Access Compliance Report

Public Rights-of-Way

(Curb Ramps)

Intersection ID: 11444		Main Street: ALLEGHANY_ST		Cross Street: MCKINLEY_DR		Location: SE			
ADA ID: C2F4C88608FB		Ramp Type: Perp		Initial Pass/Fail: Fail		Overall Compliance: No		Severity Score: 22.5	
Codes/Mitigation Info/Possible Solution					Field Measurements/Component Compliance

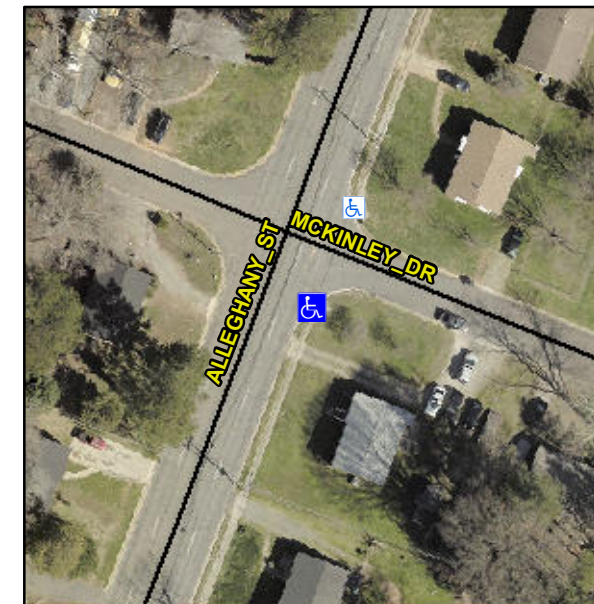
Not Found, R304.5.1, R304.2.2, R304.5.3

Compliance	Description	Data	Compliance	Description	Data
N/A	Ramp Length (in)	69.0	No	Ramp Slope (%)	8.8
No	Ramp Width (in)	44.5	No	Ramp XSlope (%)	3.6
N/A	Flare Type LT	N/A	N/A	Flare Type RT	N/A
N/A	Flare Slope LT (%)	N/A	N/A	Flare Slope RT (%)	N/A
N/A	Flare Traversable LT?	N/A	N/A	Flare Traversable RT?	N/A
N/A	Landing Length (in)	N/A	N/A	DWS Provided?	N/A
N/A	Landing Width (in)	N/A	N/A	DWS Contrast?	N/A
N/A	Landing Slope (%)	N/A	N/A	DWS Length (in)	N/A
N/A	Landing X Slope (%)	N/A	N/A	DWS Full Width?	N/A
N/A	Landing Curb? (Y/N)	N/A	N/A	DWS Offset (in)	N/A
N/A	Shared Landing?	N/A			
N/A	Gutter Ponding?	N/A	N/A	Gutter Slope (%)	N/A
N/A	Gutter Lip Ht (in)	N/A	N/A	Gutter X Slope (%)	N/A
N/A	Painted X Walk1?	No	N/A	Painted X Walk2?	N/A
	X Walk 1 Direction	To NE		X Walk 2 Direction	N/A
N/A	X Walk 1 Width (in)	N/A	N/A	X Walk 2 Width (in)	N/A
	X Walk 1 Slope (%)	5.8		X Walk 2 Slope (%)	N/A
	X Walk 1 X Slope (%)	0.9		X Walk 2 X Slope (%)	N/A

Remove & Replace Entire Ramp.
